### **Sewall Wetland Consulting, Inc.**

RE: 5637 Mercer Way – Peer review response

This letter and attached revised Critical areas report and revised Critical Area Enhancement Plan, are in response to the July 29, 2015 ESA peer review letter regarding this project.

RE: 5637 Mercer Way – Revised Critical Areas Report

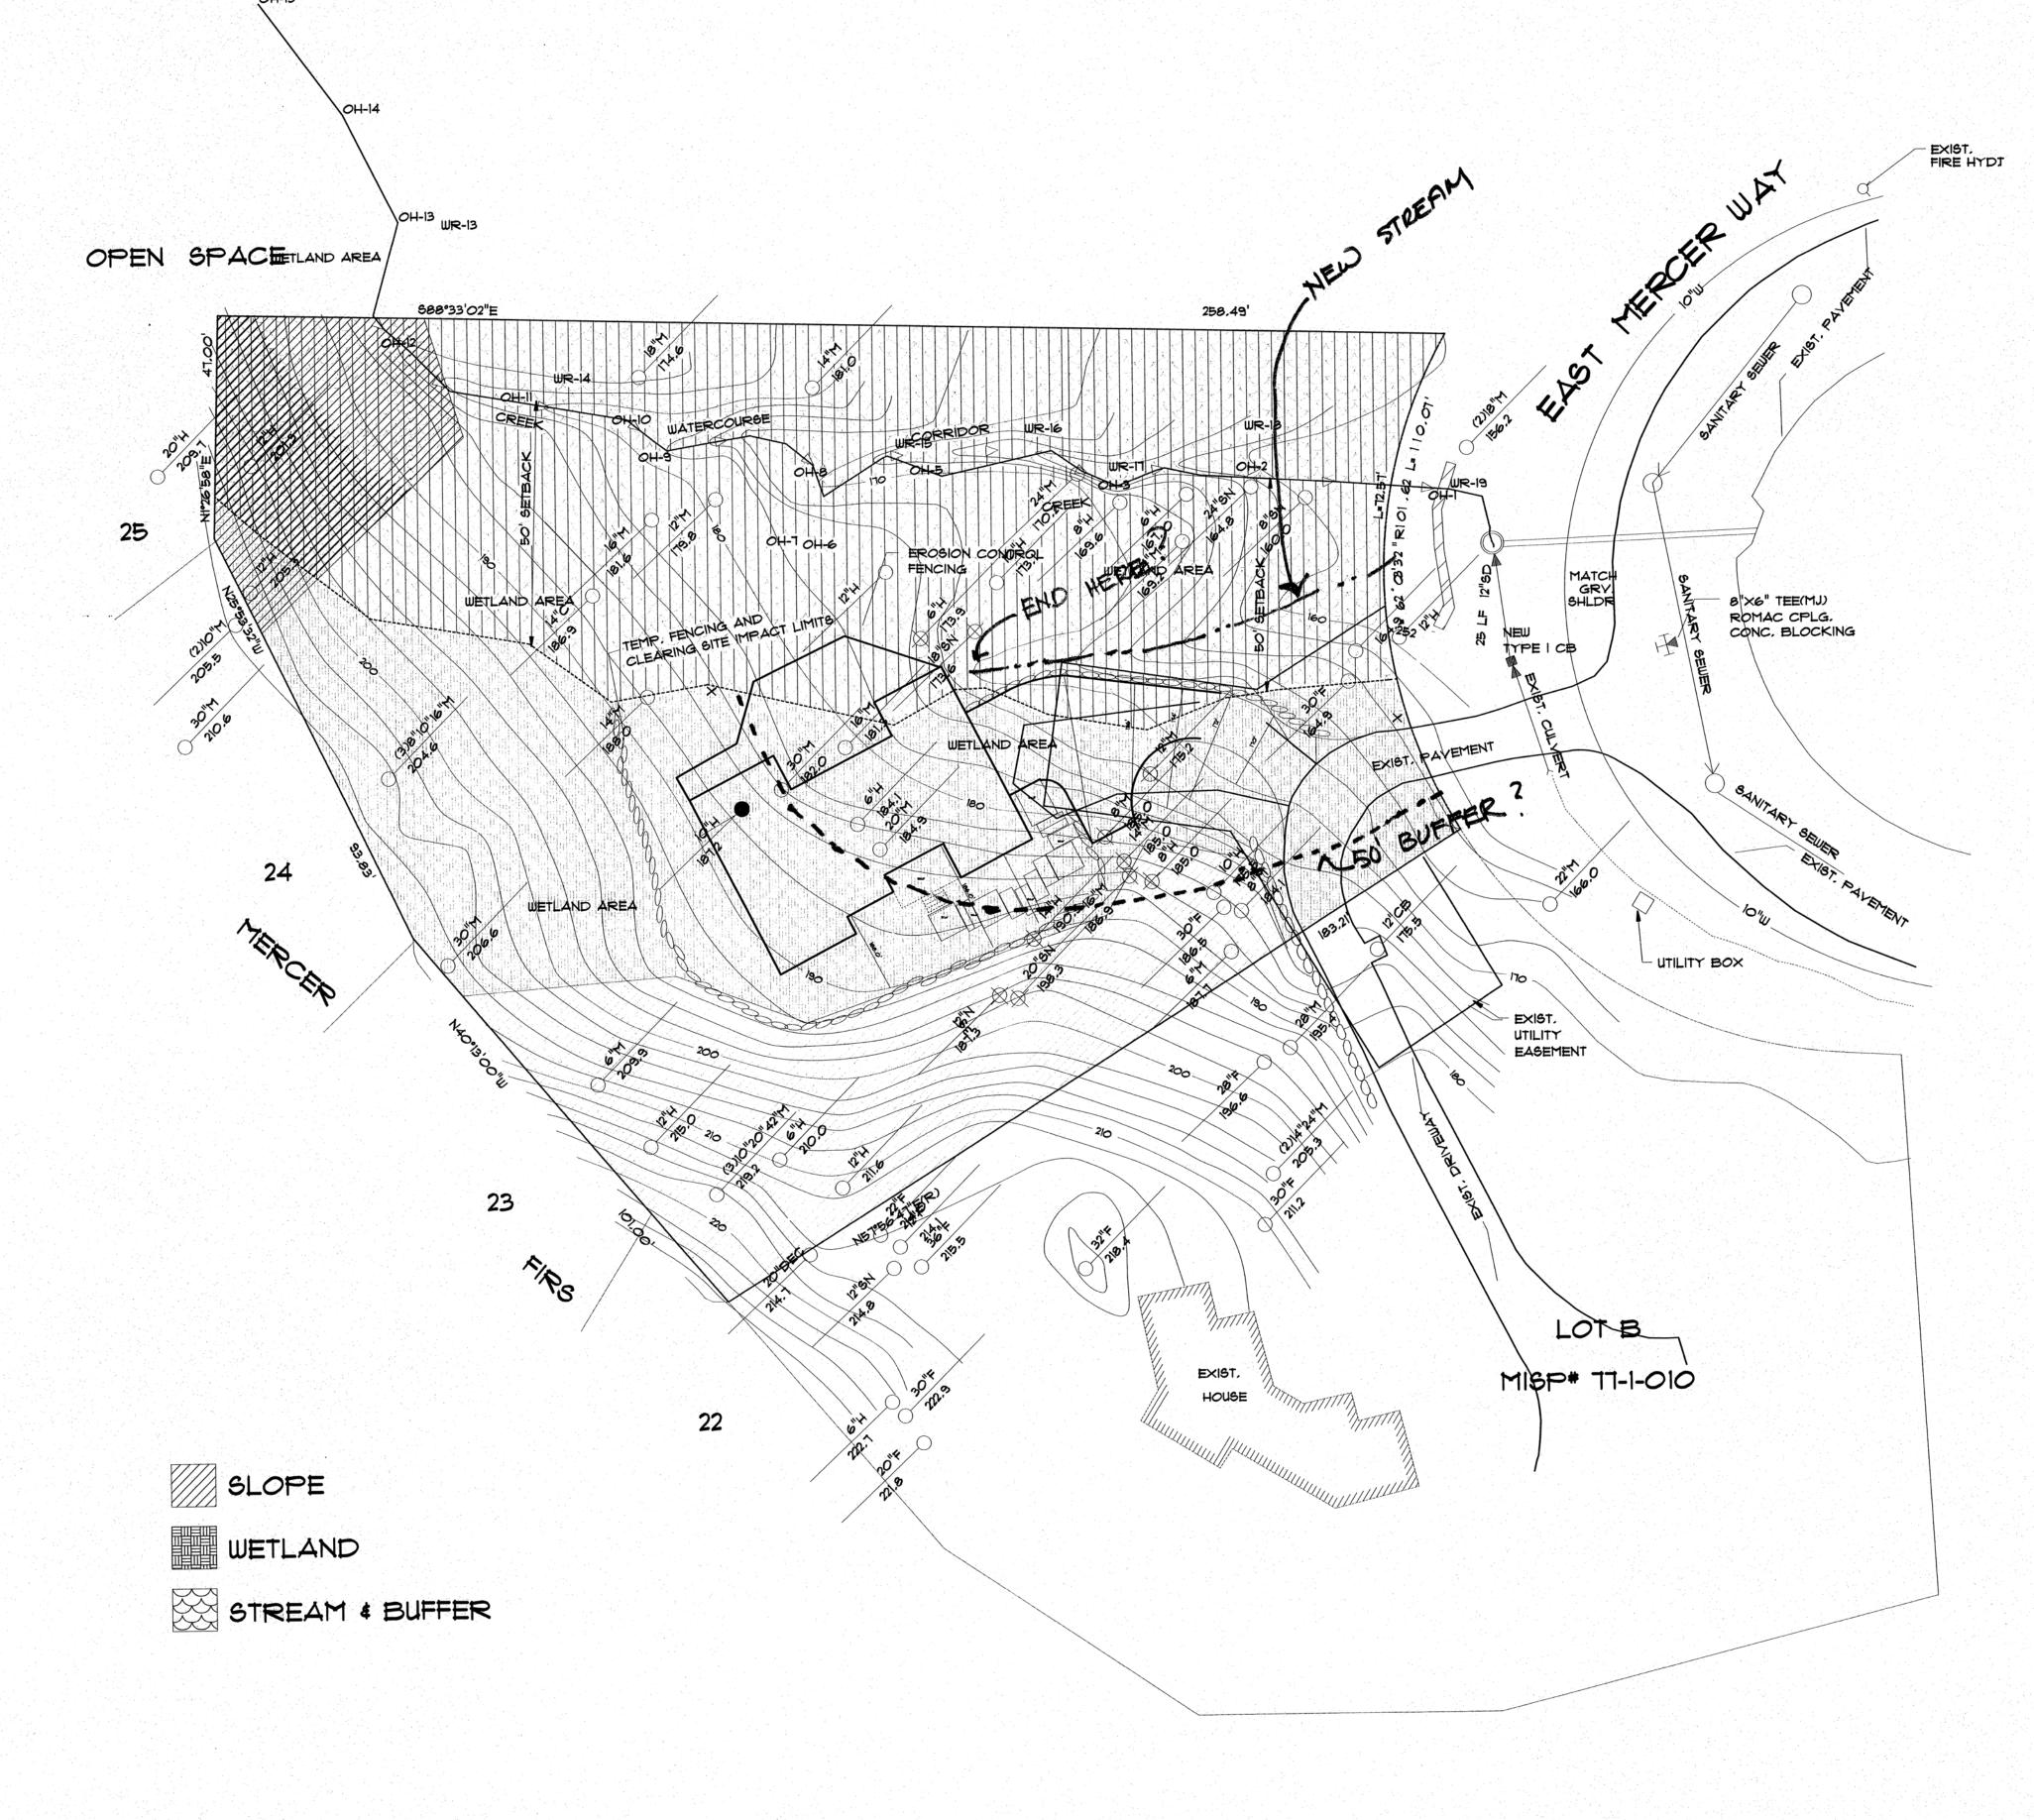
The newly identified stream should be flagged and surveyed in the field and the stream boundary and associated buffers should be included on appropriate project plans and the mitigation plan.

The critical areas enhancement plan figure, Sheet 1 of 1, should indicate the stream flows to the east.

The dirt trail on the northern parcel boundary should be surveyed and identified on appropriate project plans and the mitigation plan.

The second stream identified during the review is now depicted on the site plan as requested.

The mitigation plan has been revised to note the stream flows to the east as requested.

The trail has now been placed on the mitigation plan as requested.
